VARIANCE REQUEST

Iowa Department of Natural Resources

Re: Variance Request
Terrace Hills Sanitary Sewer Extension
Corning, Iowa

SANITARY SEWER EXTENSION
CORNING, IOWA 1997

SHEET NO.
1

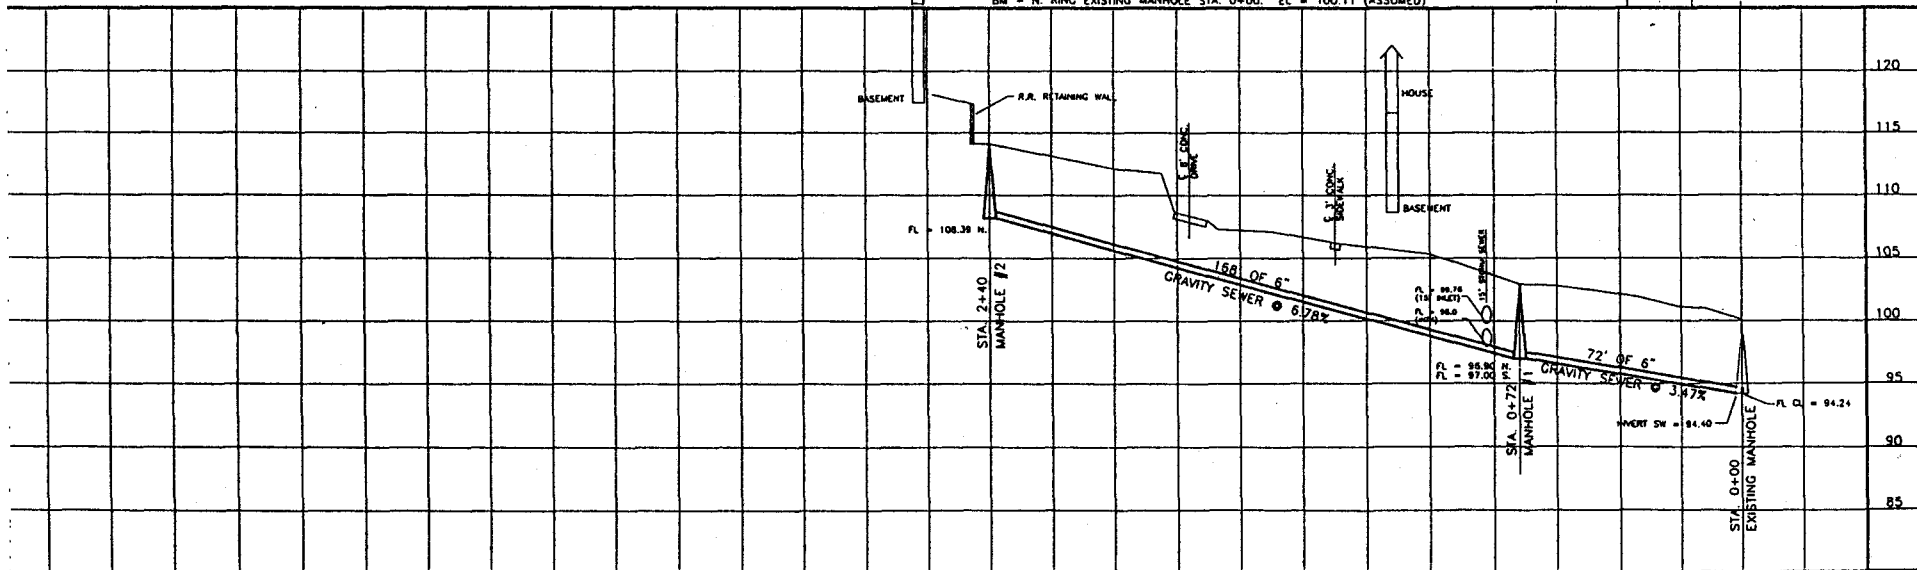
The City of Corning proposes to construct 240 feet of sanitary sewer to serve a maximum of 3 homes. In view of the limited development and since the proposed sewer will discharge into an existing 6-in. sanitary sewer, it is proposed to use 6-inch sewer for the new extension. Inasmuch as our design standards require a minimum diameter of 8-inch for sewered communities, a variance has been requested.

- 1) The service area is for two homes with the possibility of only one more home to be added to the extension.
- 2) There is no possibility of extending the sewer in any other direction because all surrounding properties are currently served.
- 3) The receiving manhole for this extension is currently served with a six-inch effluent and is hydraulically capable of the expansion of the three potential sewer services as documented in Schedule B.
- 4) The maximum hydraulic capacity of the six-inch extension flowing full is approximately 470 GPM. The peak for three homes is well below 100 GPM.

- 1) The service area is for two homes with the possibility of only one more home to be added to the extension.
- 2) There is no possibility of extending the sewer in any other direction because all surrounding properties are currently served.
- 3) The receiving manhole for this extension is currently served with a six-inch effluent and is hydraulically capable of the expansion of the three potential sewer services as documented in Schedule B.
- 4) The maximum hydraulic capacity of the six-inch extension flowing full is approximately 470 GPM. The peak for three homes is well below 100 GPM.

We concur with the engineer's proposal to use 6" diameter pipe for the proposed sanitary sewer extension based upon the above justification and the following additional considerations:

1. The proposed 6-inch sewer will discharge into an existing 6-inch sewer
2. The proposed sewer grades of 3.47% and 6.78% are considerably steeper than the minimum sewer grade of 0.34% for 6-inch sewer pipe which is approved for unsewered communities
